# BURDETTE ENGINEERING, INC.

**USC UPSTATE  
LIBRARY LIGHTING REPLACEMENT, FLOORS 1 & 2  
Project Number H34-9543-JM-F  
Spartanburg, SC**

## **ADDENDUM # 2 February 27, 2014**

1 CONDUIT REROUTING DETAIL  
E1.2 NOT TO SCALE

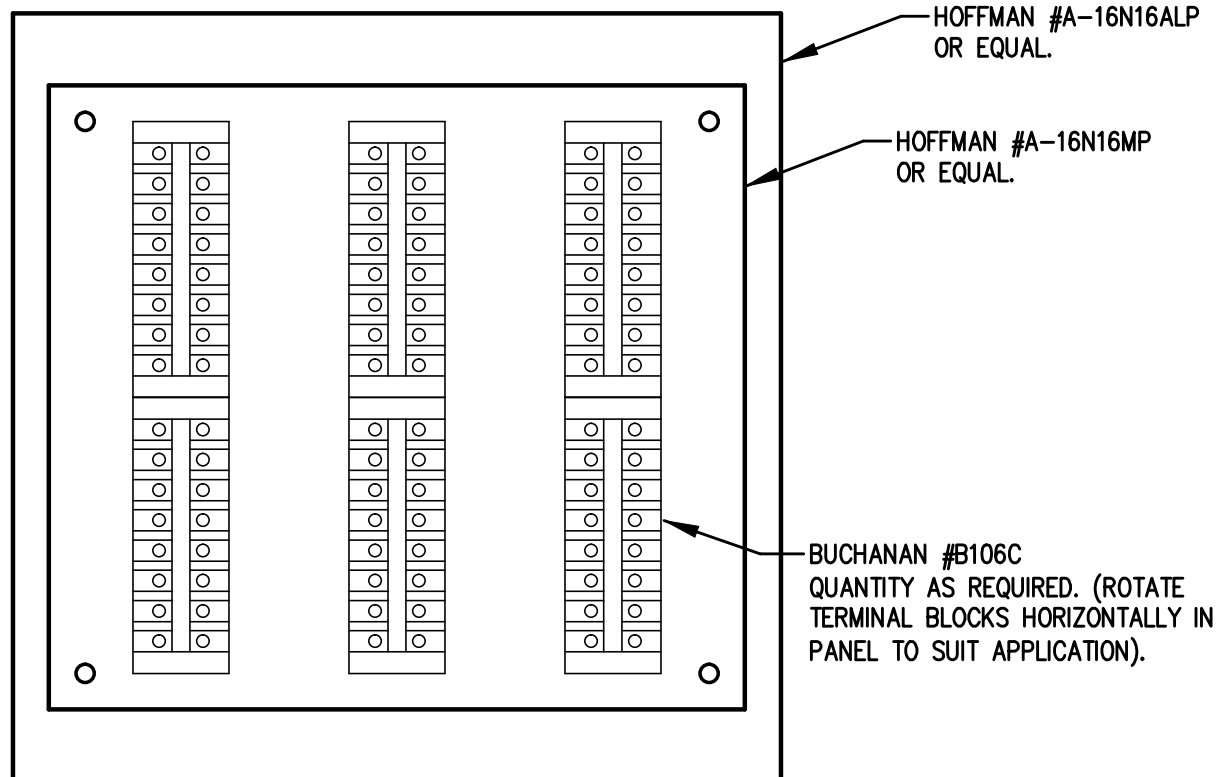
7. Drawing E1.2: In Room 228 one type TC2 fixture shall be a type TCR2 fixture instead.
8. Drawing E1.2: See SKE1 and SKE2 for rerouting of lighting circuits through new Lutron lighting control panel. See SKE3 for new location of lighting control panel.
